Olive Downs Coking Coal Project

Additional Information to the
Environmental Impact Statement

Response to IESC Advice

Figure 5-1

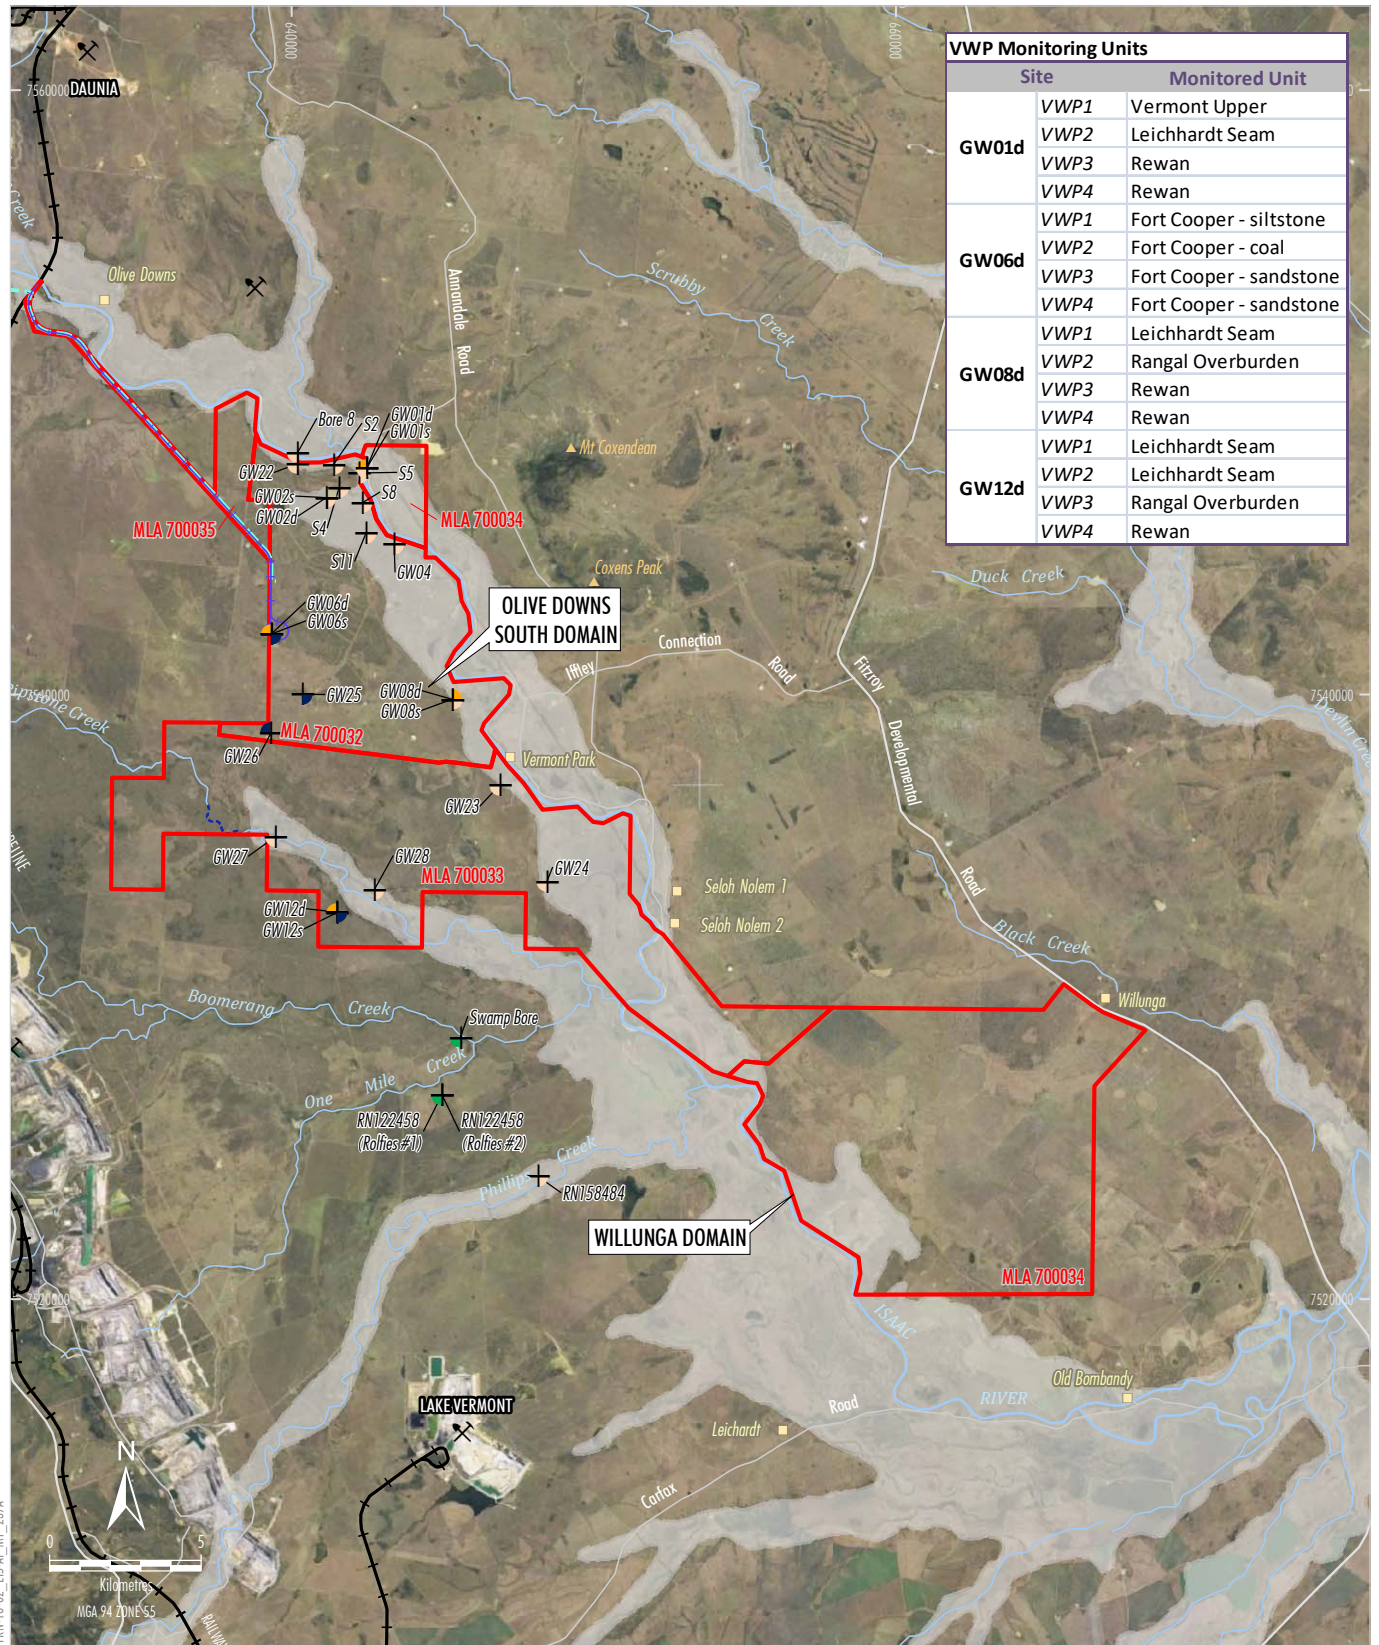
b) Update the numerical groundwater modelling once additional data have been collected

Pembroke proposes a network of reference and compliance bores be included in the EA Conditions for the Project, including proposed new monitoring locations to add to existing baseline datasets. The Stage 1 reference and compliance bores are listed in Table 5-1 and shown on Figure 5-1. As stated on Page 4-86 of the draft EIS, recording of groundwater levels from existing monitoring bores and VWPs would continue and would enable natural groundwater level fluctuations (such as responses to rainfall) to be distinguished from potential groundwater level impacts due to depressurisation resulting from proposed mining activities. Since lodgement of the draft EIS, groundwater monitoring has continued, and updated groundwater quality data has been included in Section 13.

Pembroke's approach is consistent with the IESC's suggestion. If after two years after installation of additional monitoring bores there is a significant deviation from the model predictions identified, then the model would be subject to review. The review process would involve re-running the groundwater model, confirming the revised predictions, undertaking any additional consultation deemed necessary and adjusting the proposed control measures as required.

Figure 5-8: Comparison of DataDrill vs Stochastic Rainfall Data

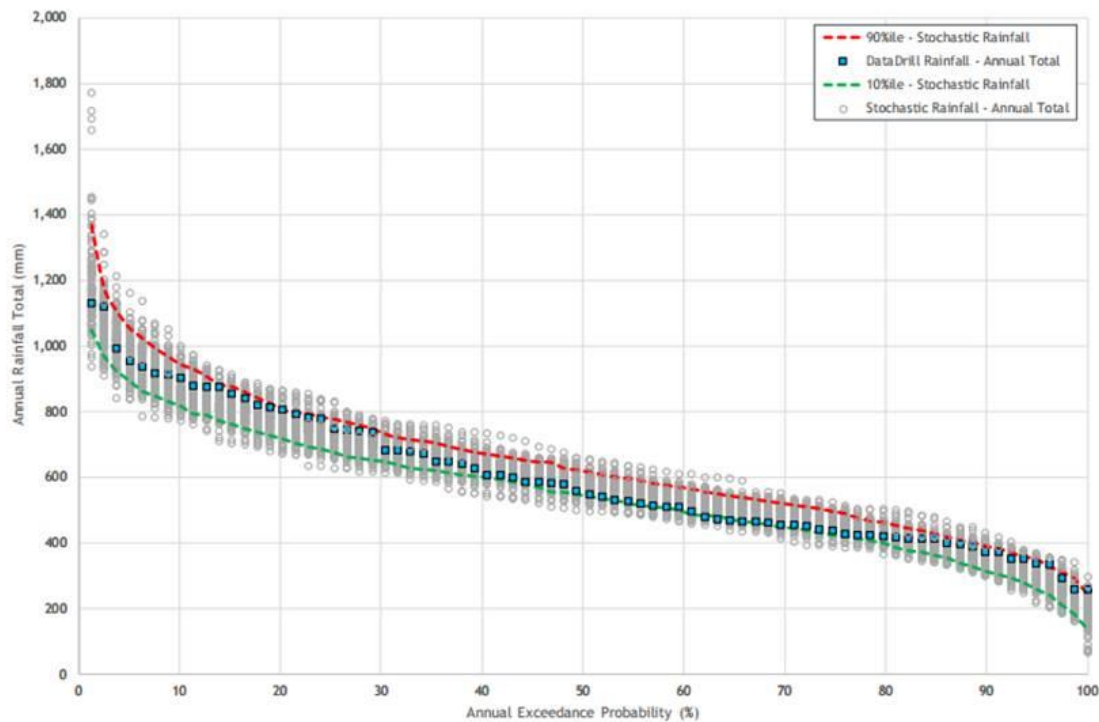
The natural inputs to the mine water management system are based on an Australian Water Balance Model (AWBM) (which has been calibrated to only one catchment of the Isaac River) and the use of stochastic rainfall replicates. It is concerning that the median observed annual rainfalls coincide with the lower (90%) bound of the synthetic series (Figure 5.8, Appendix E), which suggests that the typical annual synthetic inflows are biased high. However, this "high bias" would be partially offset by the underestimation of streamflows obtained using the AWBM model (Figure 7.5, Appendix E). Overall, it is possible that the water usage requirements associated with the predicted 10% (dry) climatic conditions are representative of the likely future typical (50%) requirements, without allowing for climate change. For example, the external makeup requirements associated with a 10% probability of exceedance might be better regarded as being associated with median climatic conditions. If this is of critical concern, then the efficacy of the stochastic rainfall replicates should be revised to be more consistent with local observations.

As described in Section 5.2.2.1 of the draft EIS Surface Water Assessment (Hatch, 2018) report, a stochastically generated rainfall dataset was produced to provide a sufficient number of climatic sequences, given the long mine life. This stochastic rainfall dataset was generated using the Stochastic Climate Library (SCL) software, using the SILO rainfall data as the source data. The SCL software is effectively a "black box" type program, and does not provide any ability to modify parameters or settings which can change the results.

To test the efficacy of the program, WRM compared the source (SILO) rainfall data against the generated rainfall data (Figure 5-8 of the Surface Water Assessment reproduced below). This showed that, when ranked, the historical annual rainfall totals were generally within the 10th and 90th percentile bounds of the stochastic annual totals.

Some of the historical data was closer to the 10th percentile, some closer to the 90th percentile and some near the median. In WRM's opinion, the stochastically generated data was successfully replicating the historical data with a reasonable amount of variation and the use of the adopted stochastic rainfall dataset is acceptable for the following reasons:

- The SCL program has been designed specifically for this purpose (i.e. the generation of stochastic climate data based on historical climate data for Australian conditions). There are few other programs available which can generate daily climate sequences, especially for Australian conditions.
- While the position of the historical data varies between the 10th and 90th percentiles, the range of annual totals for the stochastic data at each AEP is fairly tight, with the spread increasing somewhat for the highest rainfall years (AEP <5%). Therefore the difference between the 10% and 90% totals is fairly small. Discounting the top 3 values, the average variation is only 85 mm/year. For most years, this equates to a variation of around 10-15% annual rainfall total.

- Any potential “bias” in the stochastic rainfall data is minor, and any uncertainty associated with the rainfall data would be captured within the sensitivity analysis presented in Section A.3 and A.4 of the Surface Water Assessment. As part of this sensitivity assessment, the AWBM soil capacity was adjusted by +/- 20% and the predicted impacts on the performance of the water management system was presented.
- Therefore, in WRM’s opinion, the uncertainty associated with the generation of the stochastic rainfall data is adequately addressed through the model sensitivity analysis process.
